# Memorandum

**RE:** **Schoettler Grove SDP:** A Site Development Plan, Landscape Plan, Tree Preservation Plan, Tree Stand Delineation Plan, and Architectural Elevations for a 17.0 acre tract of land zoned "PUD" Planned Unit Development located northwest of the intersection of Clayton Road and Schoettler Road.

## Planning Commission Staff Report

**Description:** **Schoettler Grove SDP:** A Site Development Plan, Landscape Plan, Tree Preservation Plan, Tree Stand Delineation Plan, and Architectural Elevations for a 17.0 acre tract of land zoned "PUD" Planned Unit Development located northwest of the intersection of Clayton Road and Schoettler Road.

Figure 1: Area Zoning

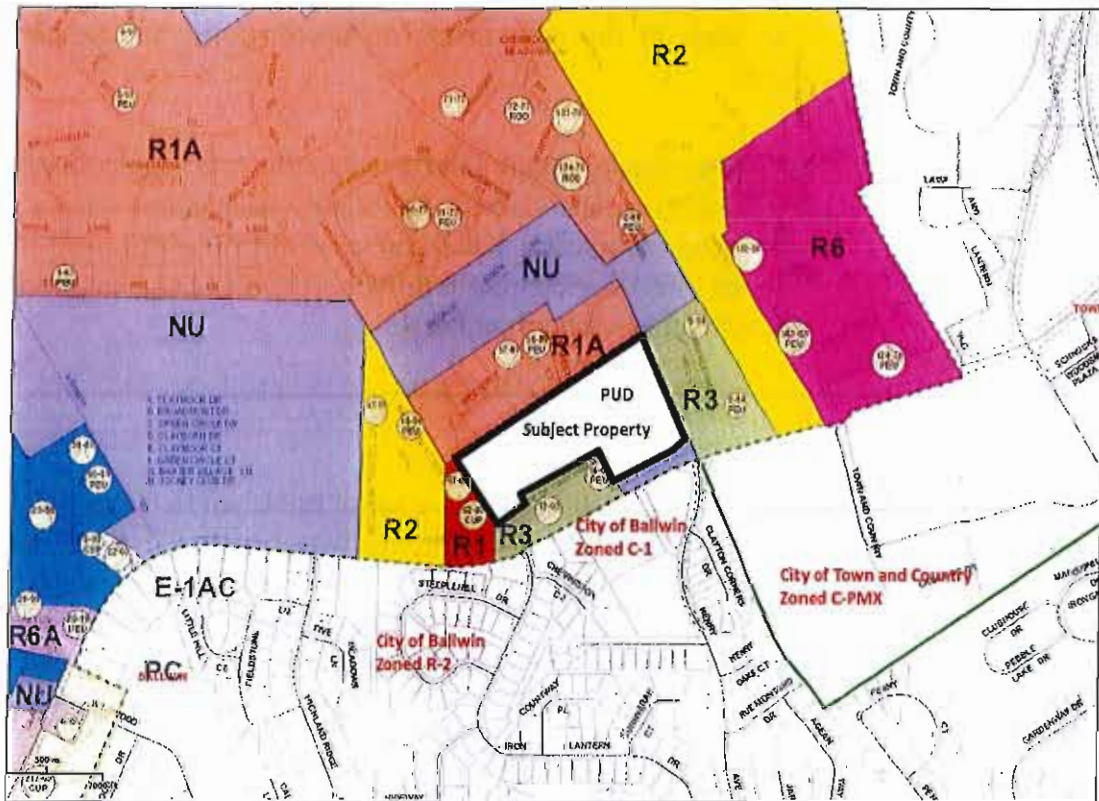
**North:** The land uses of the properties to the north are single family residential within the Westerly Place subdivision which is zoned R1A/PEU Residence District with a Planned Environmental Unit.

**South:** The properties to the south are single-family attached dwellings within the Gascony subdivision which is zoned R-3/PEU Residence District with a Planned Environmental Unit and a commercial shopping area within the City of Ballwin, zoned C-1 Commercial with a Neighborhood Commercial Overlay.

**East:** Properties east of the site have a land use of single family residential within the Amberleigh subdivision which is zoned R-3/PEU Residence District with a Planned Environmental Unit.

**West:** The property to the west is St. Louis Retirement development containing multi-family uses zoned R-1 Residence District with a Conditional Use Permit (CUP).
